Access Compliance Report Public Rights-of-Way (Curb Ramps)

Main Street: LA_LOMA_DR		Cross Street: ARROYO_AVE		Location:	S
ADA ID: RPRK211012125547	Ramp Type: Type 4 - Parallel	Initial Pass/Fail: Fail	Overall Compliance: No	Severity Score:	19

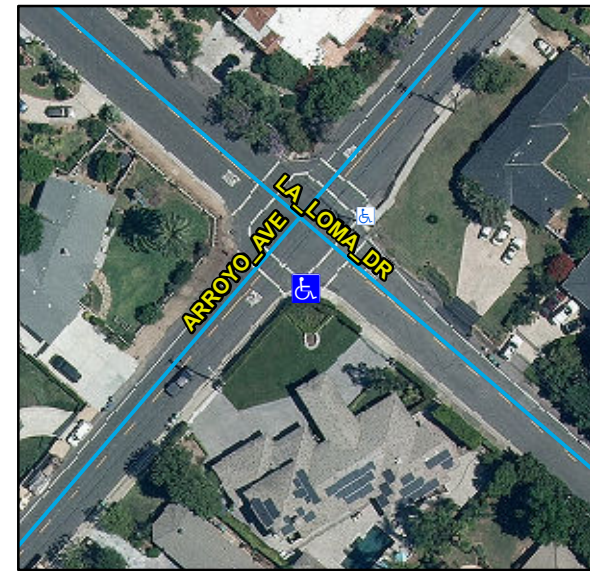
Compliance	Description	Data	Compliance	Description	Data
N/A	Ramp Length LT (in)	132	N/A	Ramp Length RT (in)	124
No	Ramp Width LT (in)	46	No	Ramp Width RT (in)	43
No	Ramp Run Slope LT (%)	8.7	Yes	Ramp Run Slope RT (%)	3.7
Yes	Ramp Cross Slope LT (%)	0.1	Yes	Ramp Cross Slope RT (%)	0.2
N/A	Landing Present	N/A	N/A	DWS Provided	N/A
N/A	Landing Length (in)	N/A	N/A	DWS Contrast	N/A
N/A	Landing Width (in)	N/A	N/A	DWS Length (in)	N/A
N/A	Landing Run Slope (%)	N/A	N/A	DWS Full Width	N/A
N/A	Landing Cross Slope (%)	N/A		DWS Offset Type	N/A
N/A	Landing Movement Obstructed?	N/A	N/A	DWS Offset Left (in)	N/A
	Landing Movement Type	N/A	N/A	DWS Offset Right (in)	N/A
N/A	Landing Shared	N/A			
N/A	Clear Space	Yes			
N/A	Clear Space To Crosswalk (in)	48			
N/A	Marked Crosswalk 1	Yes	N/A	Marked Crosswalk 2	Yes
	Crossing 1 Direction	NE		Crossing 2 Direction	NW
	Marked Crosswalk 1 Width (in)	120		Marked Crosswalk 2 Width (in)	144

N/A	Ramp Inside Crosswalk 1	Yes	N/A	Ramp Inside Crosswalk 2	Yes
	Crossing 1 Slope (%)	4.2		Crossing 2 Slope (%)	8.2
	Crossing 1 Cross Slope (%)	2.4		Crossing 2 Cross Slope (%)	3.7
N/A	Gutter Ponding	N/A	N/A	Curb Slope	17
Yes	Gutter Lip Height (in)	0		Road Run Slope (%)	2.1
N/A	Gutter Run Slope (%)	N/A		Road Cross Slope (%)	8.7
N/A	Gutter Cross Slope (%)	N/A	Yes	Perpendicular Joint Present	Yes
Yes	Overall Surface Condition	Acceptable			
	Cross Gutter Present?	No		Spandrel Present?	No
	Replace Cross Gutter?	N/A		Replace Spandrel?	N/A

Remove & Replace Curb Ramp With Two New Directional Ramps or Equivalent.
